# GXV3240/GXV3275 Firmware Release Note

## FIRMWARE VERSION 1.0.3.171

GXV3240, GXV3275

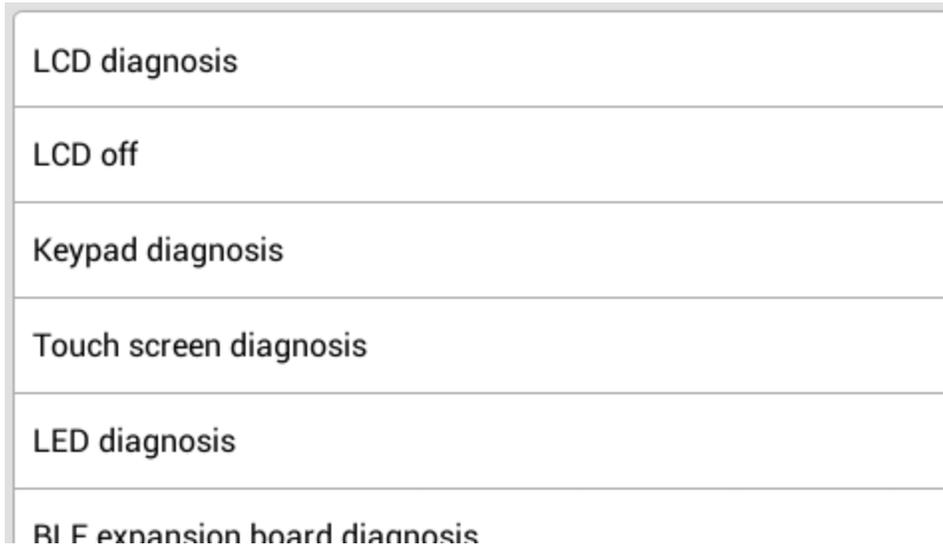
- Supported "Click to Dial" feature on web UI. In web UI top right, click on the call button  to open Click to Dial. The interface is shown as below:
